# TX Module Schematics

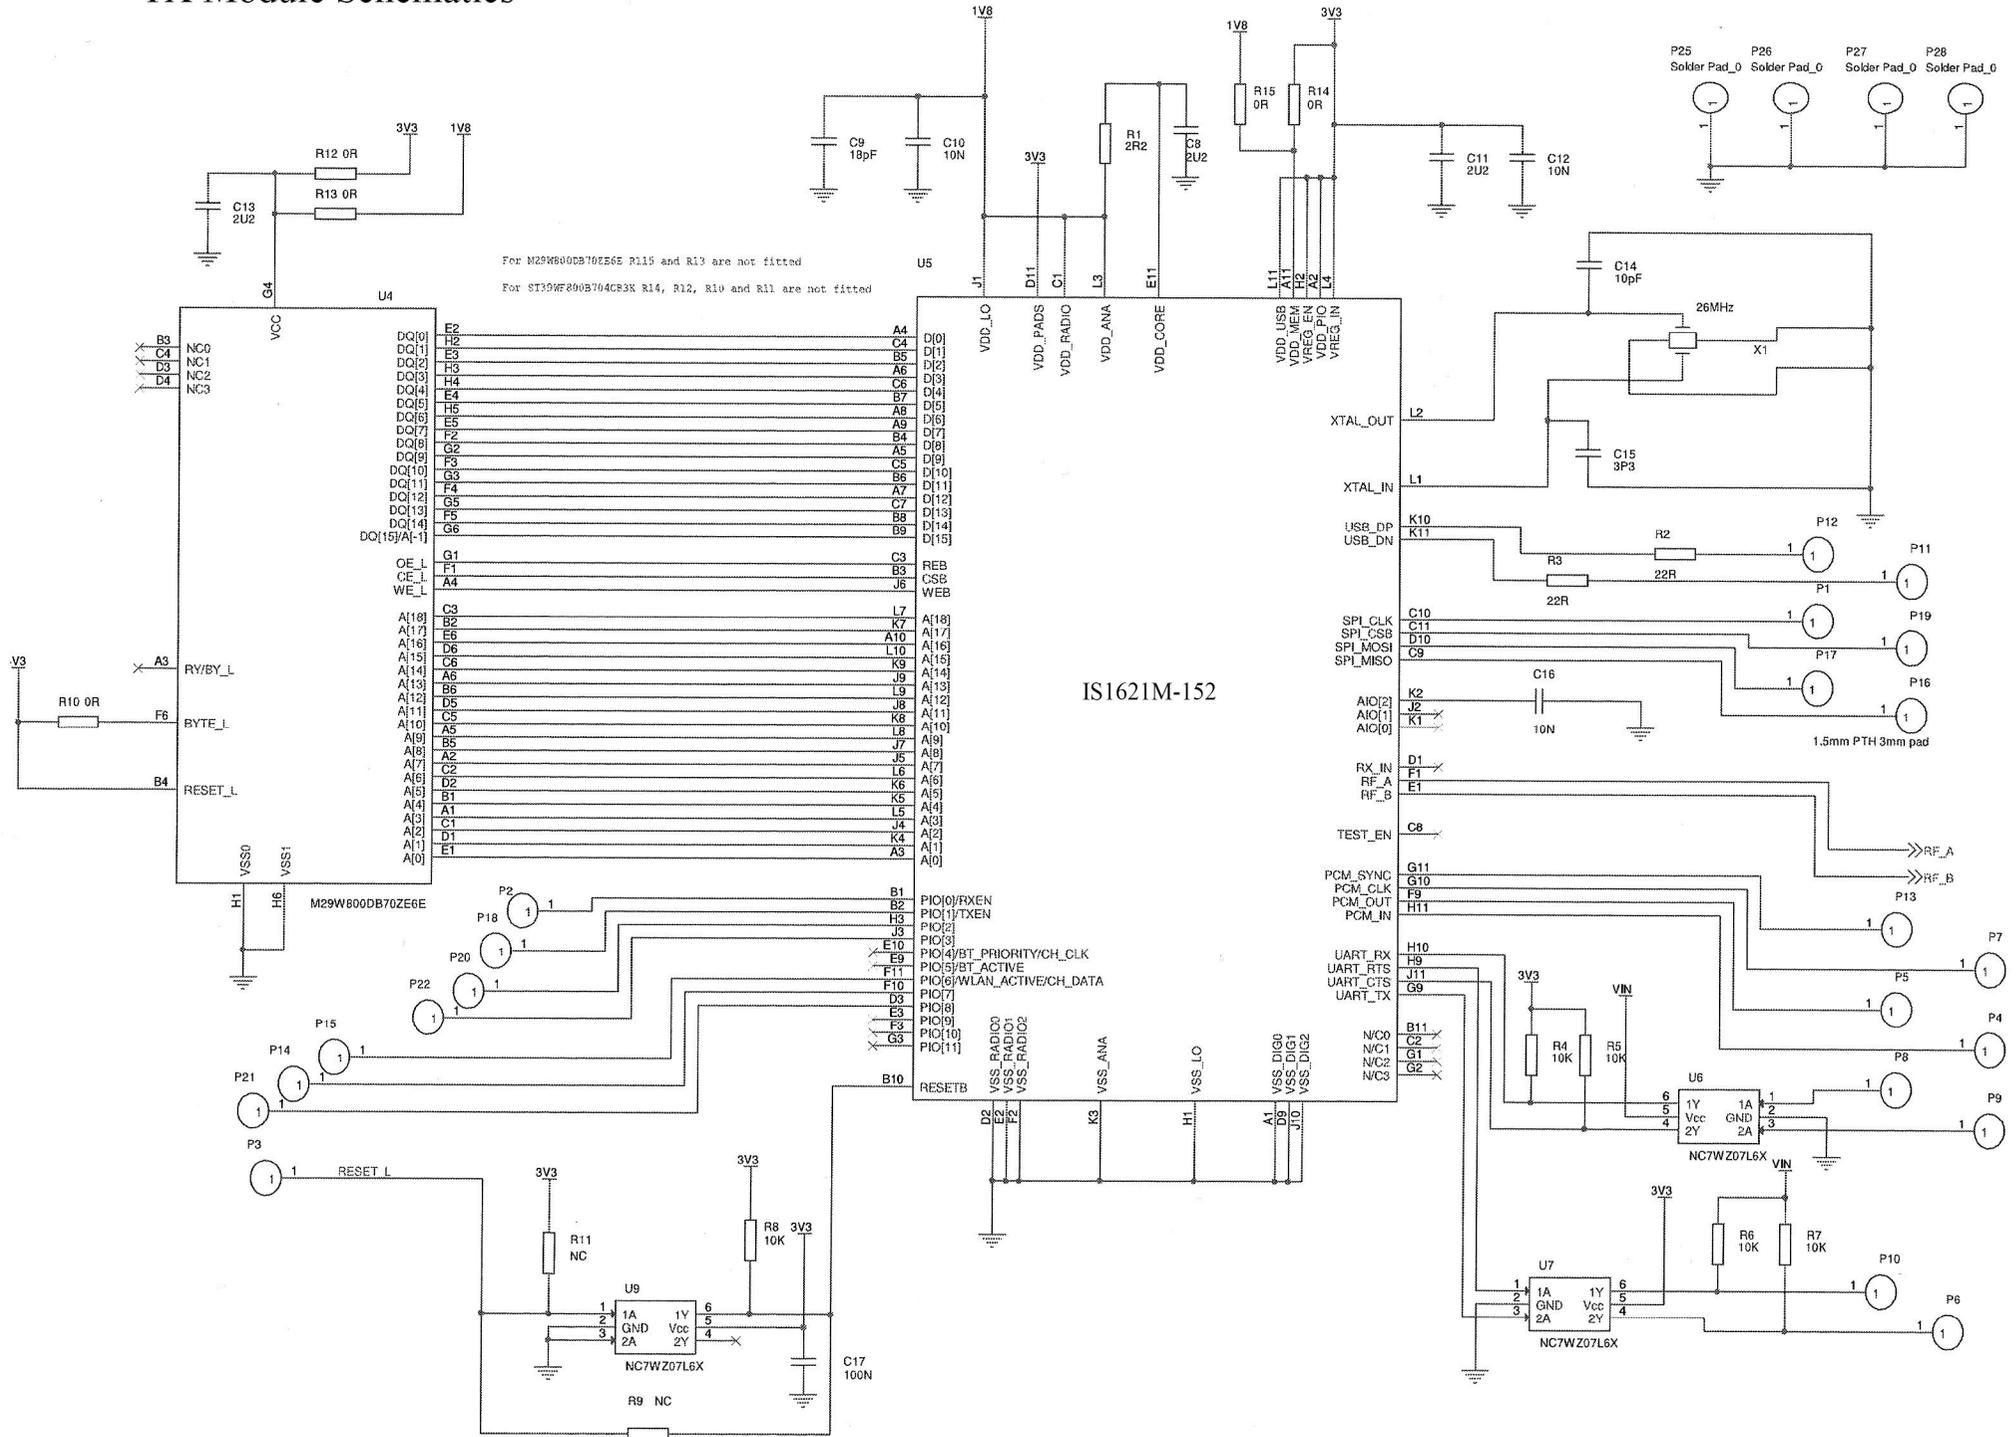
C4 removed, L3 was 3N6, L4 was 2N7, ANT1 was 2450AT18B100E
